# Access Compliance Report

## Public Rights-of-Way

### (Curb Ramps)

Intersection ID: 53417	Main Street: SOUTHGROVE_ST	Cross Street: WAVERLY_WALK_AV	Location: NE
ADA ID: 14BEA2D56BA4	Ramp Type: BlendTrans1	Initial Pass/Fail: Fail	Overall Compliance: No
		Severity Score: 10

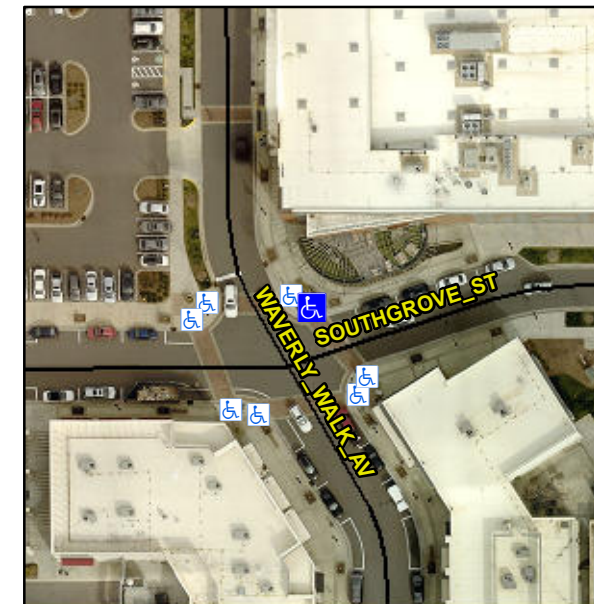
**Not Found, R304.5.1, R304.5.3**

Compliance	Description	Data	Compliance	Description	Data
N/A	Ramp Length (in)	71.0	Yes	BlendTrans Slope (%)	2.3
No	Ramp Width (in)	45.0	No	BlendTrans XSlope (%)	2.8
N/A	Flare Type LT	N/A	N/A	Flare Type RT	N/A
N/A	Flare Slope LT (%)	N/A	N/A	Flare Slope RT (%)	N/A
N/A	Flare Traversable LT?	N/A	N/A	Flare Traversable RT?	N/A
N/A	Landing Length (in)	N/A	N/A	DWS Provided?	N/A
N/A	Landing Width (in)	N/A	N/A	DWS Contrast?	N/A
N/A	Landing Slope (%)	N/A	N/A	DWS Length (in)	N/A
N/A	Landing X Slope (%)	N/A	N/A	DWS Full Width?	N/A
N/A	Landing Curb? (Y/N)	N/A	N/A	DWS Offset (in)	N/A
N/A	Shared Landing?	N/A			
N/A	Gutter Ponding?	N/A	N/A	Gutter Slope (%)	N/A
N/A	Gutter Lip Ht (in)	N/A	N/A	Gutter X Slope (%)	N/A
N/A	Painted X Walk1?	Yes	N/A	Painted X Walk2?	N/A
	X Walk 1 Direction	To SE		X Walk 2 Direction	N/A
	X Walk 1 Width (in)	104.0		X Walk 2 Width (in)	N/A
	X Walk 1 Slope (%)	0.8		X Walk 2 Slope (%)	N/A
	X Walk 1 X Slope (%)	0.9		X Walk 2 X Slope (%)	N/A

N/A	Ramp inside XWalk1?	Yes	N/A	Ramp inside XWalk2?	N/A
	Road Slope (%)	0.9		Clear Space?	N/A
	Road X Slope (%)	0.8	N/A	Clear Space to XWalk (in)	N/A
N/A	Any Obstructions?	N/A	N/A	Storm Grate/Utility Hazard?	N/A
	Obstruction Type			Storm Grate/Utility Type	
		N/A			N/A
			Yes	Surface Condition? (G/P)	Good
			No	Curb Slope (%)	11.6

**Remove & Replace Curb Ramp With Two New Directional Ramps or Equivalent.**
